MEMORANDUM

To: Design Review Board
From: Jon Regala, Senior Planner
Date: April 25, 2013
File No.: DRV13-00192
Subject: PHASE I - LAKE STREET PLACE DESIGN RESPONSE CONFERENCE
(CONTINUED FROM MARCH 18, 2013)

Lake Street Place – Phase I - Kirkland Waterfront Market

① SOUTH ELEVATION
 1/8" = 1'-0"

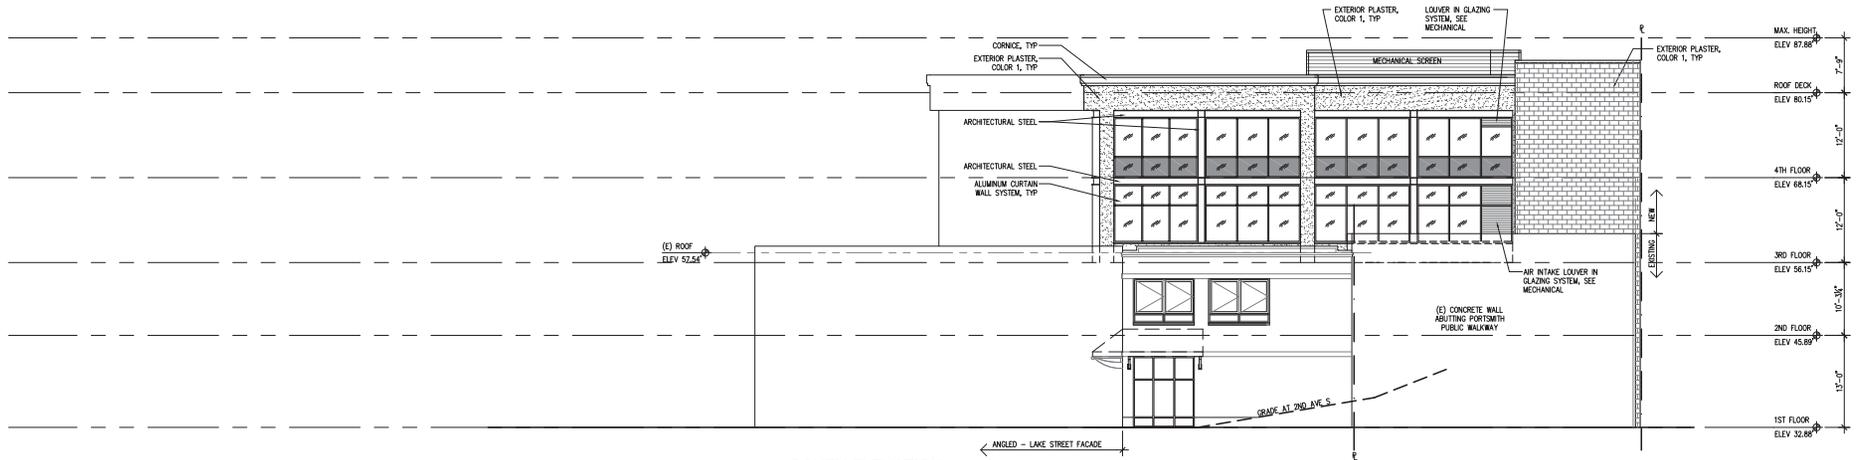
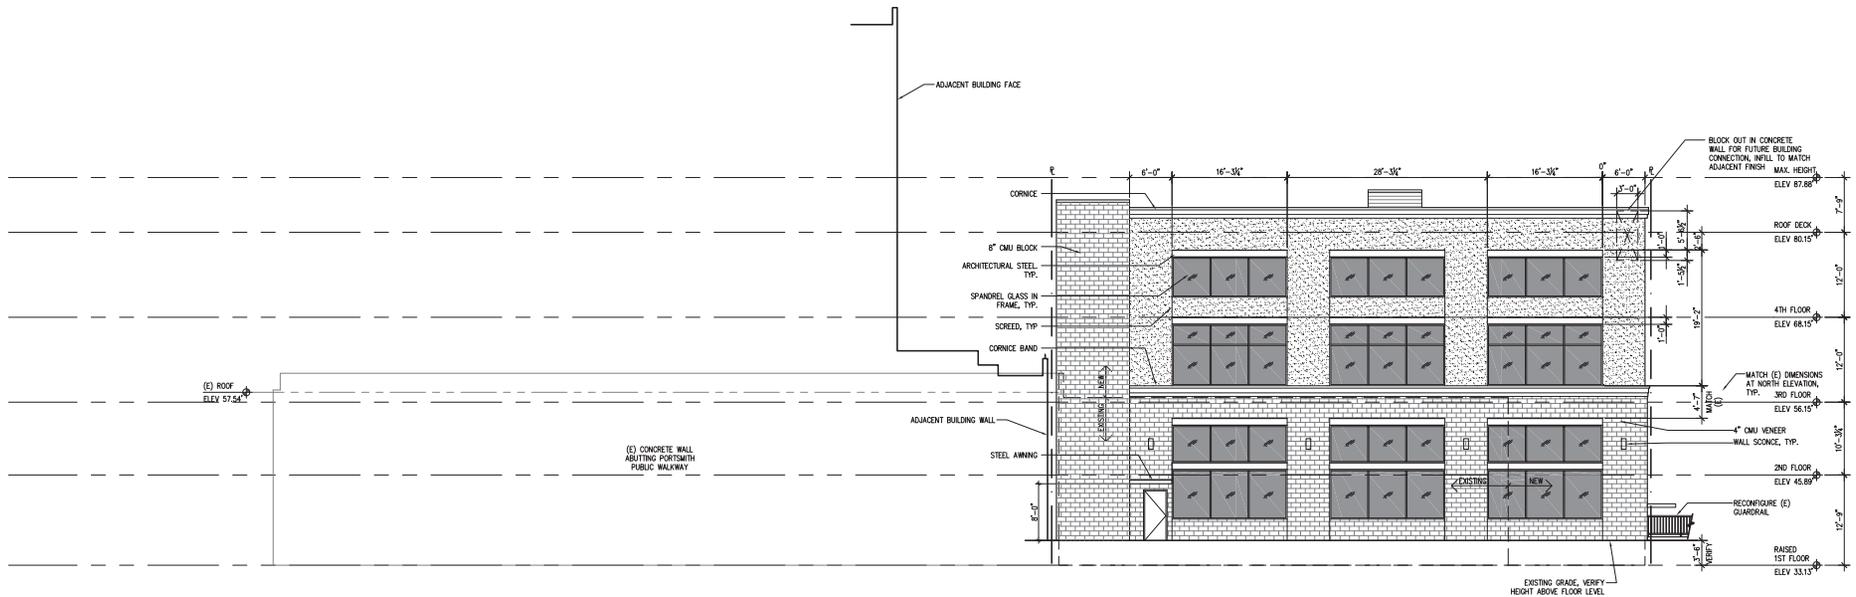
The DRB asked the applicant to revisit the building's north and east façade design. The north and east facades of the proposed Kirkland Waterfront Market addition are visible from key vantages - Lake Street and Main Street. As proposed, the building design was not comparable nor did it reflect the quality of the previously approved Lake Street Place project.

In addition, windows have been added to the north and east facades in response to the DRB's concerns. Previously, the windows were articulated but did not contain glass. The windows along the east façade are made of spandrel glass to provide privacy.

The DRB should determine what changes, if any should be made to the building facades based on the design guidelines topics listed below.

- We have modulated the east façade by dividing the elevation into 2 different sections.
- The first section begins at the northeast corner and is about 72'-0" long and at the 1st and 2nd stories are clad with a 4" CMU block veneer which frames 3 bays of aluminum windows frames with spandrel glass and painted steel headers above the window frames. The CMU veneer is then capped with a MDO wood painted double fascia and painted metal cap. A painted steel canopy is shown above the painted metal door leading to the 1st floor level hallway. The 3rd and 4th stories are finished with exterior plaster with painted exposed steel headers and aluminum window frames with spandrel glass. The plaster then is capped with a plaster double horizontal band and metal flashing cap.

- The second section is the 8" CMU block cladding at the southeast stair tower. The block is capped with a metal flashing cap.
- We are also proposing to install wall sconces between the window frames that will wash the wall with up/down light.

- We are proposing an 8" CMU block wall cladding at the new walls for the southeast stair tower. The block is capped with a metal flashing cap.
- The primary materials for the south façade consist of a horizontal and vertical steel channel detail framing the openings for the aluminum "curtain wall" window system and an exterior plaster column, upper parapet wall, and overhang and the exterior plaster color matches the color of the existing 1st and 2nd story walls at the KWM.
